Appendix C: Sydney Water Email

From:	Stormwater <stormwater@sydneywater.com.au></stormwater@sydneywater.com.au>	
Sent:	Wednesday, 7 February 2018 11:44 AM	
To:	Nicholas Rouggos	
Cc:	Nick Howard; Greg Shargorodsky	
Subject:	RE: PSD & SSR Requirement (Metro Martin Place - South and North Towers)	
Follow Up Flag: Follow up		
Flag Status:	Completed

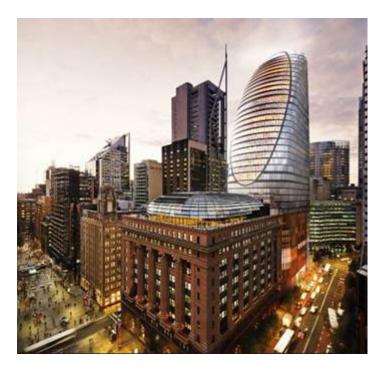
South Tower

Development Address: Refer to image below

Area: 1920m2

You can use the following On Site Detention parameters for the both North and South towers:

٠	On Site Detention	16 cubic meters for every 1000 square meters of site area
٠	Permissible Site Discharge	36 L/s for every 1000 square meters of site area

You may design oversizing On Site Detention tank to compensate by pass area such a way that total Permissible Site Discharge remain same for your development site.

Generally, more than 30% of the site area should not be by passed. However individual circumstances can be considered on its merit basis.
